Landscape Referral Response

Application Number:	DA2023/1708
Date:	18/01/2024
Proposed Development:	Demolition works and construction of a Recreation Facility (indoor) with signage
Responsible Officer:	Gareth David
Land to be developed (Address):	Lot 2743 DP 752038 , 431 Pittwater Road NORTH MANLY NSW 2100

Figure 1:

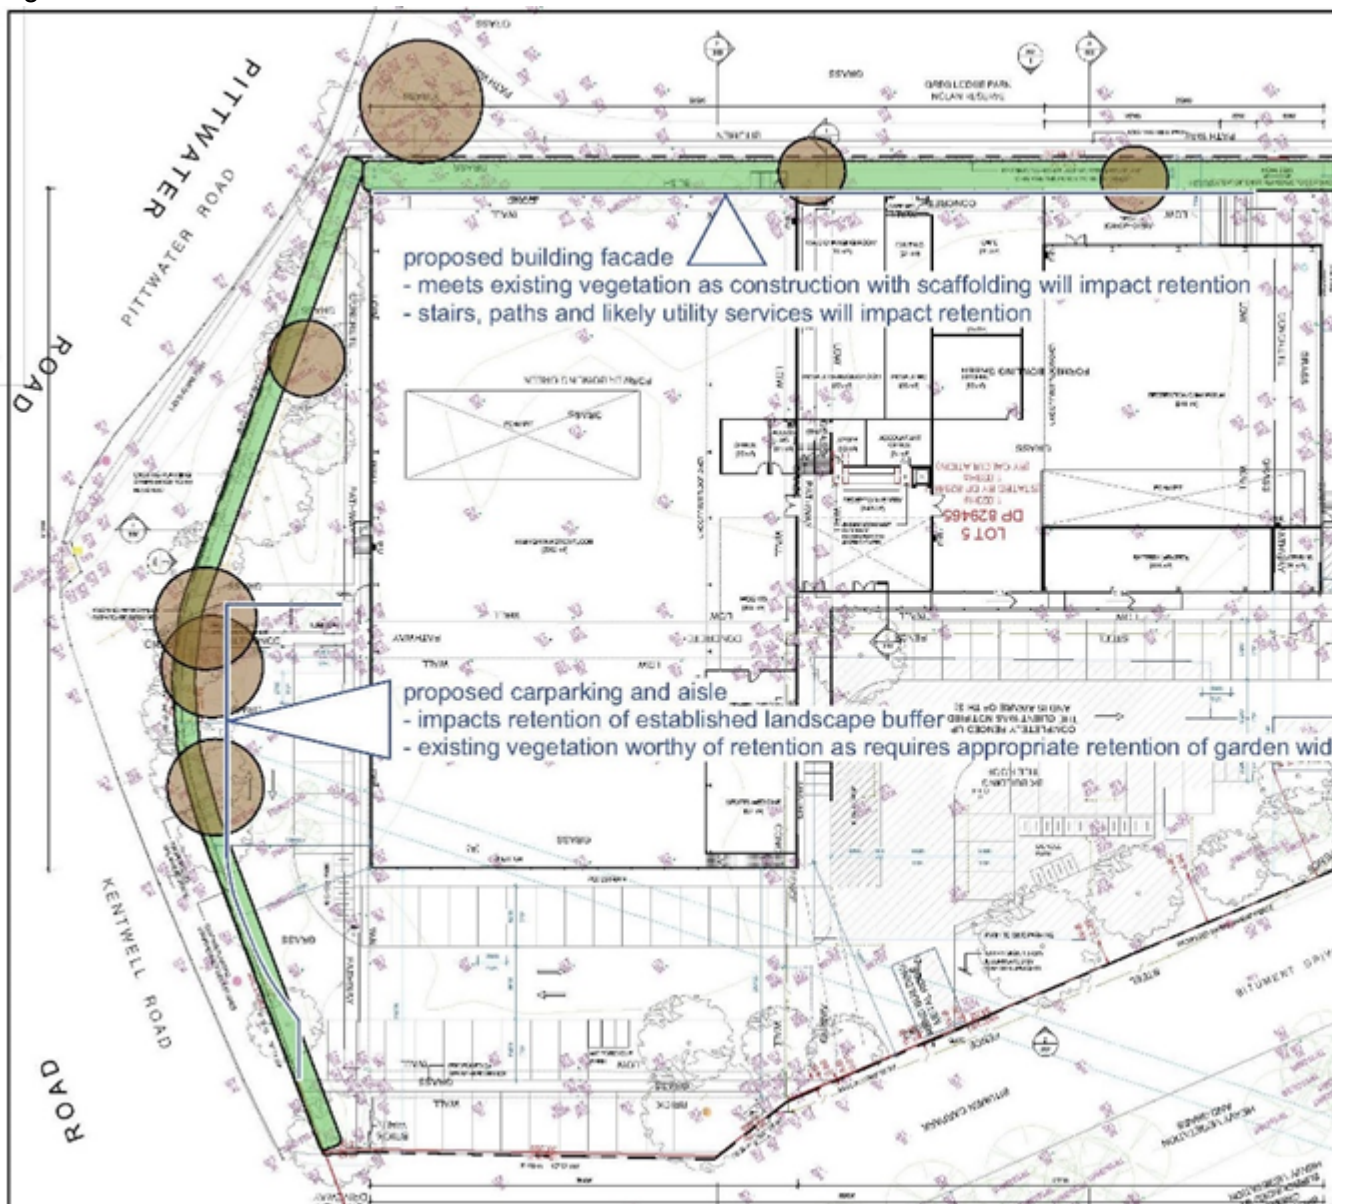
- Whilst the Plans including the Landscape Plans indicate retention of the existing vegetation planting along the eastern common boundary with Nolan Reserve, an overlay prepared by Landscape Referral (refer figure 1) indicates that the documentation is not accurate in locating the existing elements relative to the proposed works, as the existing vegetation is in fact located in close proximity to the proposed building wall alignment such that expected construction scaffolding and access will require removal of all the existing vegetation. It is noted that the AIA report lists the existing vegetation as exempt species however this is incorrect as the exempt provisions of the WDCP only apply to private land and not public land. Furthermore as the setback zone of 3.0 metre is subject to structures such stairs, paths for fire egress, and most likely utility services, the available width for replacement planting with small trees and other vegetation is not likely to establish in a zone interrupted by structures.

- Whilst the Plans including the Landscape Plans indicate retention of the existing vegetation planting along the streetscape boundaries of Pittwater Road and Kentwell Road, an overlay prepared by Landscape Referral (refer figure 1) indicates that the documentation is not accurate as the existing trees and other vegetation are impacted by the proposed works.

- The existing landscape buffer frontage to Pittwater Road and Kentwell Road is a prominent landscape feature that should be preserved and it is noted that the AIA report notes the following trees: T2 and T22 (Swamp Cypress), T24 (Weeping Bottlebrush) as high retention value trees and these shall be preserved through limiting encroachment into the tree protection zone. The Plans including Landscape Plans do not indicate retention. Additionally Landscape Referral consider that T24 (Crepe Myrtle) located within the vegetation hedge is worthy of retention and note that the exempt provision for the species does not apply. For information, contrary to the Plans and including Landscape Plans, the AIA report identifies the following trees for retention: 1, 2, 5, 8, 9, 10, 11, 14, 17, 20, 21, 22 and 24, and all plans and reports shall be co-ordinated.

- Review of the built elements that will be located within the 3.0 metre setback zone adjoining Nolan Reserve to provide at least an unobstructed 2.0 metre wide landscape buffer zone to support small

- Review hard surface layout impacting the existing prominent landscape tree and vegetation buffer along the streetscape of Pittwater Road and Kentwell Road to preserve this existing landscape buffer.
- Consider shade tree planting to car parking areas, and it is suggested that parking bays should be removed to accommodate tree planting.
- Remove all proposed lease boundary fencing that offends public access.
